Access Compliance Report Public Rights-of-Way (Curb Ramps)

Intersection ID: 48786	Main Street: LOST_OAK_RD	Cross Street: ALEXANDER_RD	Location: SW
ADA ID: 5E2C70BC4C75	Ramp Type: PerpDiag	Initial Pass/Fail: Fail	Overall Compliance: No Severity Score: 10

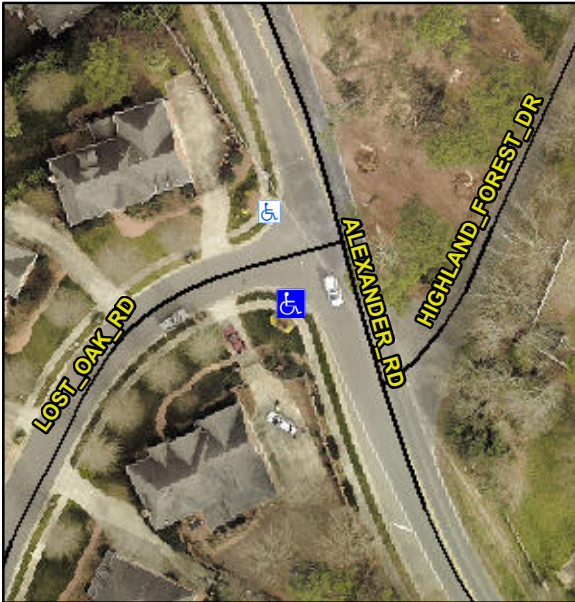
Not Found, R304.5.1, R304.5.3

Compliance	Description	Data	Compliance	Description	Data
N/A	Ramp Length (in)	113.0	Yes	Ramp Slope (%)	7.2
No	Ramp Width (in)	45.0	No	Ramp XSlope (%)	2.9
N/A	Flare Type LT	N/A	N/A	Flare Type RT	N/A
N/A	Flare Slope LT (%)	N/A	N/A	Flare Slope RT (%)	N/A
N/A	Flare Traversable LT?	N/A	N/A	Flare Traversable RT?	N/A
N/A	Landing Length (in)	N/A	N/A	DWS Provided?	N/A
N/A	Landing Width (in)	N/A	N/A	DWS Contrast?	N/A
N/A	Landing Slope (%)	N/A	N/A	DWS Length (in)	N/A
N/A	Landing X Slope (%)	N/A	N/A	DWS Full Width?	N/A
N/A	Landing Curb? (Y/N)	N/A	N/A	DWS Offset (in)	N/A
N/A	Shared Landing?	N/A			
N/A	Gutter Ponding?	N/A	N/A	Gutter Slope (%)	N/A
N/A	Gutter Lip Ht (in)	N/A	N/A	Gutter X Slope (%)	N/A
N/A	Painted X Walk1?	No	N/A	Painted X Walk2?	No
	X Walk 1 Direction	To E		X Walk 2 Direction	To N
N/A	X Walk 1 Width (in)	N/A	N/A	X Walk 2 Width (in)	N/A
	X Walk 1 Slope (%)	1.8		X Walk 2 Slope (%)	1.1
	X Walk 1 X Slope (%)	1.8		X Walk 2 X Slope (%)	1.3

Remove & Replace Curb Ramp With Two New Directional Ramps or Equivalent.
